Access Compliance Report

Public Rights-of-Way

(Curb Ramps)

| Intersection ID: 21797 | Main Street: GALLERIA_BV | Cross Street: MONROE_RD | Location: SE |

| ADA ID: A78BFDC4BDEB | Ramp Type: Perp | Initial Pass/Fail: Fail | Overall Compliance: No |

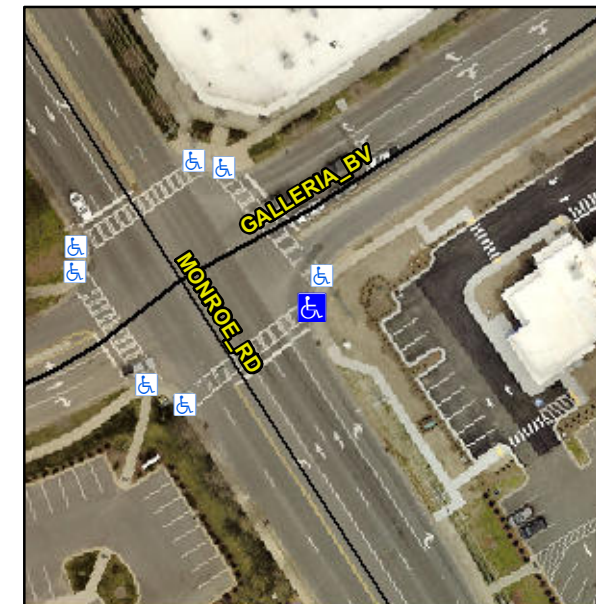
| Severity Score: 22.5 | | | |

R304.5.1, R304.2.2, R304.5.3

| Compliance | Description | Data | Compliance | Description | Data |
|------------|-----------------------|-------|------------|-----------------------------|------|
| N/A | Ramp Length (in) | 37.0 | No | Ramp Slope (%) | 10.9 |
| No | Ramp Width (in) | 44.0 | No | Ramp XSlope (%) | 3.3 |

Remove & Replace Entire Ramp.
